ENGINEERING CHANGE NOTICE

Proj. ECN B-714-53

Block 5: B-714, GROUT VAULT PAIR (218-E-16-102 & 103)(218-E-16-104 & 105)/EDMC
Block 9: ECN B-714-17, B-714-22, B-714-30, B-714-42
Block 8: **AFFECTED DOCUMENTS (Drawings)**

13a. Justification (mark one)	13b. Justification Details
Criteria Change ■ Design Improvement ■ Environmental ☐ As-Found ☐ Facilitate Const. ■ Const. Error/Omission ☐ Design Error/Omission ■	CRITERIA CHANGE to separate Safety Class 2 & 3 wiring; ITEM #'s 6, 7, 17, 22, 23 & 34 (Ref WHC-SD-B714-W-QAPP-001, REV 4) ALL OTHER ITEMS are miscellaneous design improvements, drawing errors, design clarification and ease of construction changes.

KAISER ENGINEERS HANFORD	ENGINEERING CHANGE NOTICE SKETCH					
Ref. Dwg. H-2-78509	Sh. 1	Rev. 0	Prepared By A.R. SNOWHITE	Checked By	ECN No. B-714-53	Page 47/49

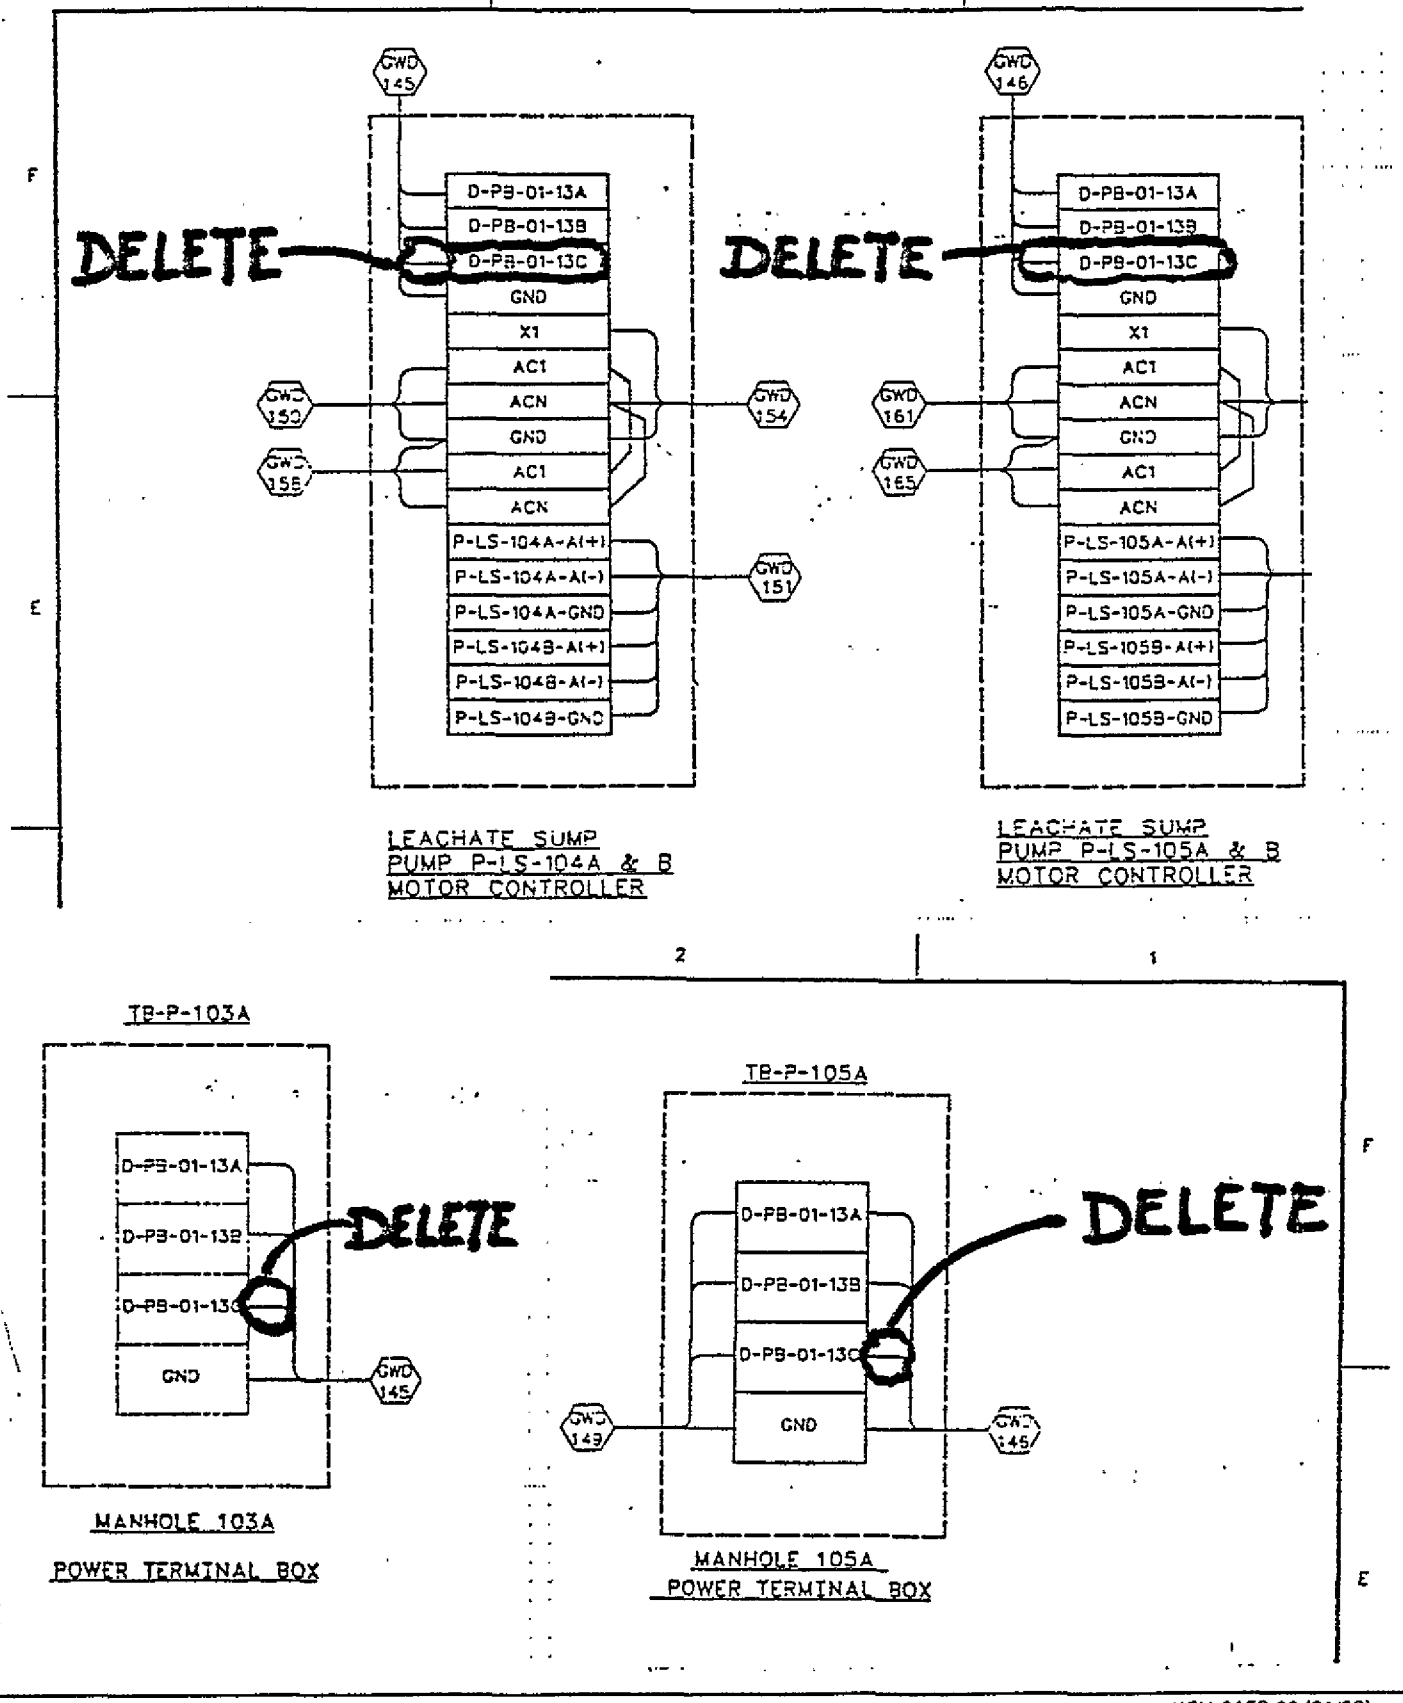
37) H-2-78509, SH 1, REV 0
Modify - see page 47 of this ECN

KAISER ENGINEERS HANFORD	ENGINEERING CHANGE NOTICE SKETCH					
Ref. Dwg. H-2-78510	Sh. 1	Rev. 0	Prepared By A.R. SNOWHITE	Checked By C. Dubbert	ECN No. B-714-53	Page 48/49

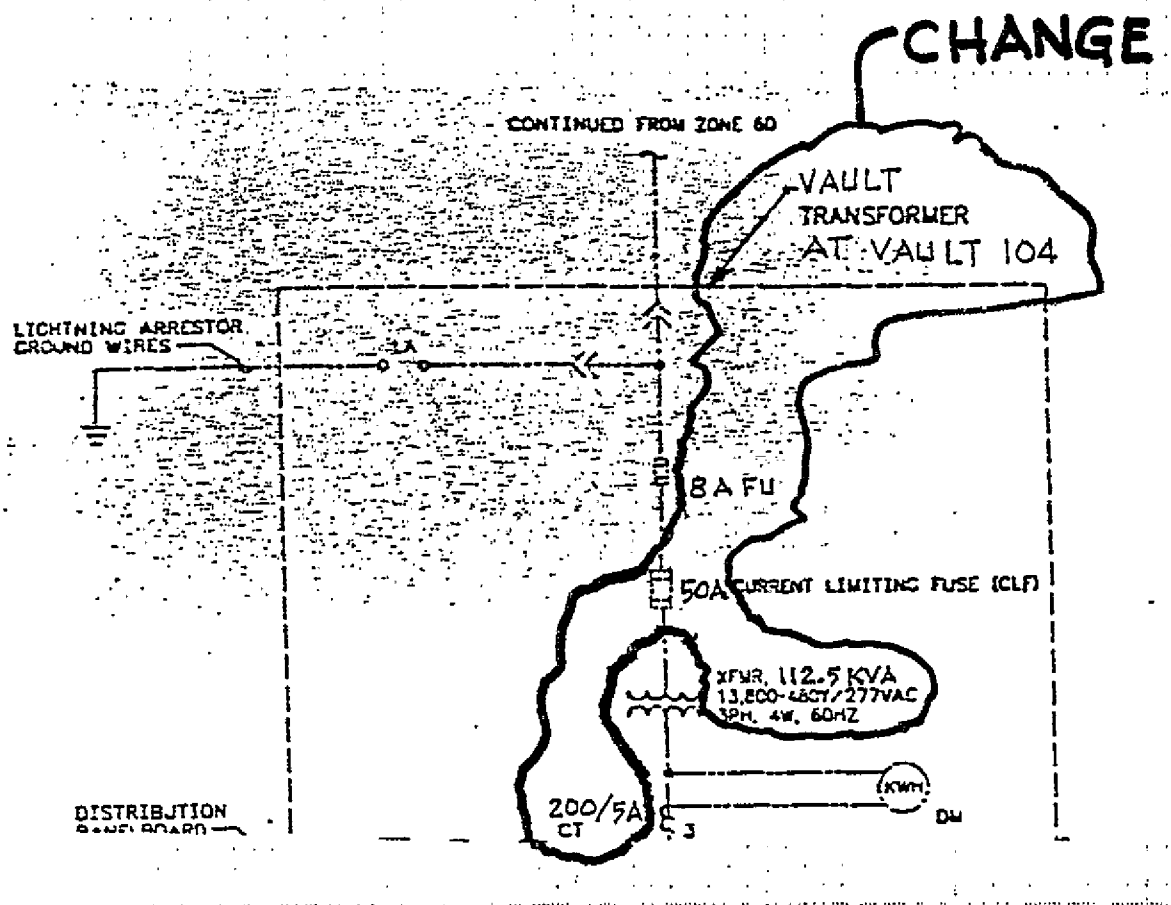
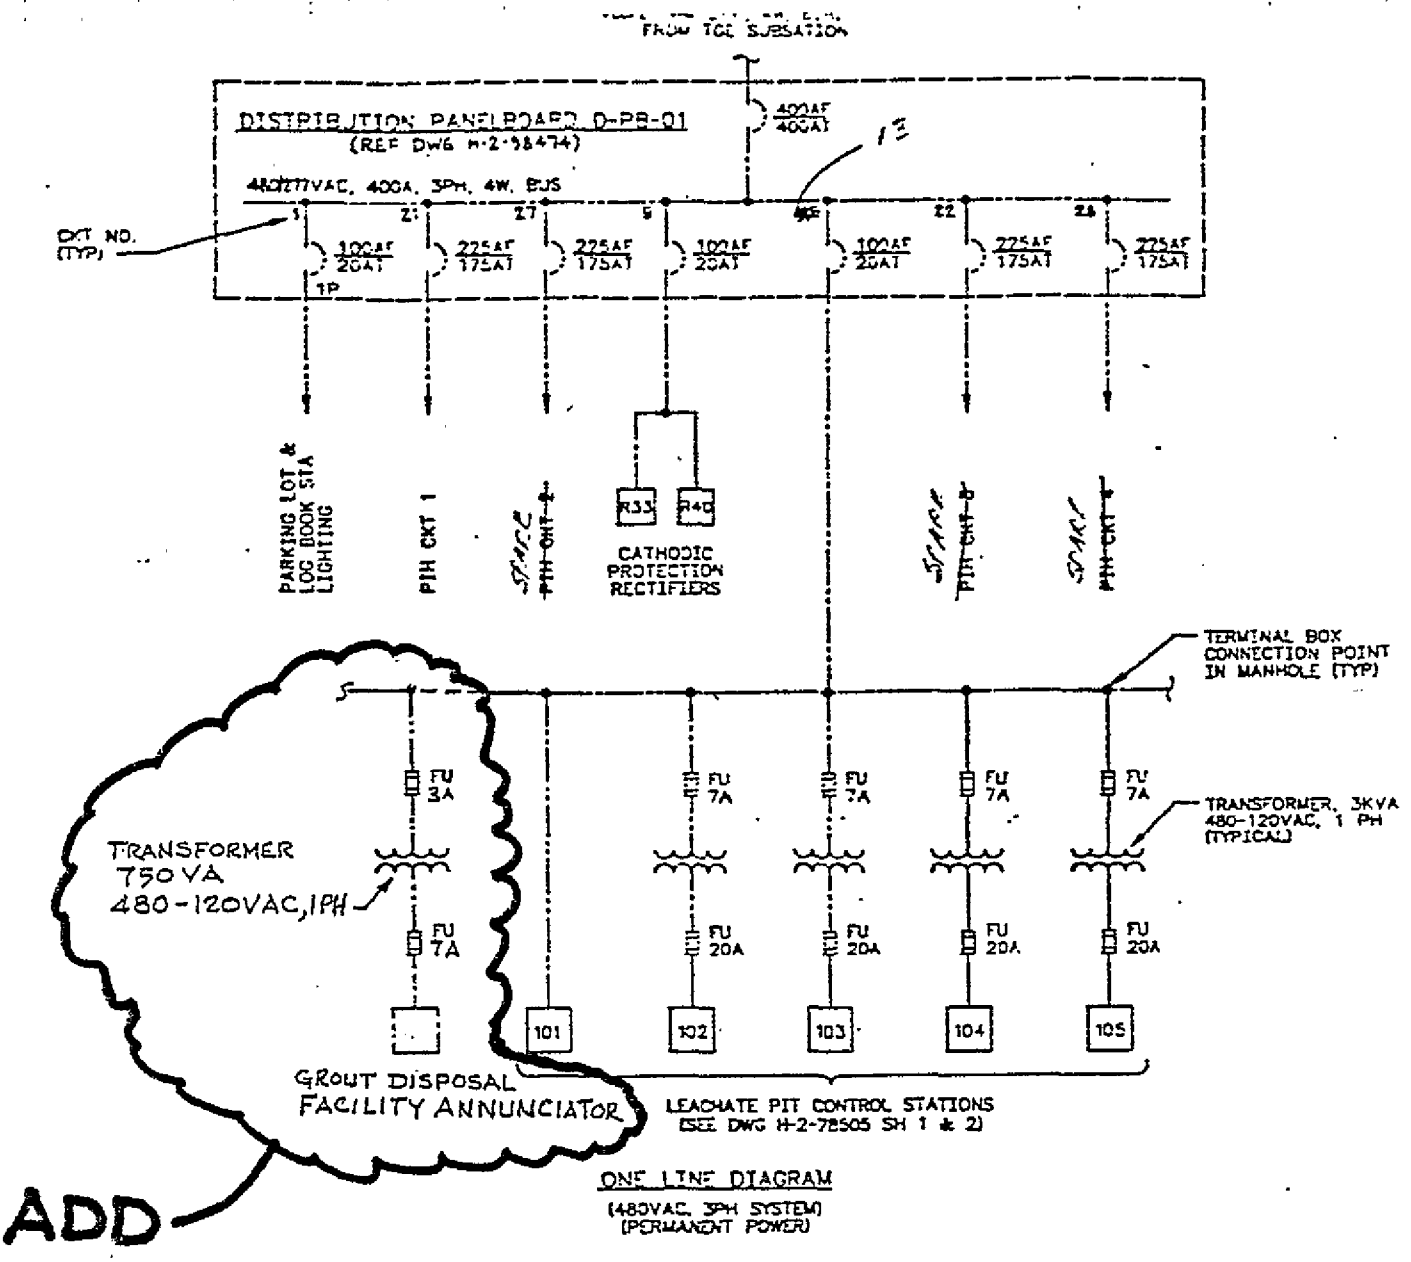
38) H-2-78510, SH 1, REV 0
- A) 13.8KVAC ONE LINE (ZD5-F4): Modify - see page 48 of this ECN
- B) 480VAC ONE LINE (ZC-D3): Modify - see page 49 of this ECN
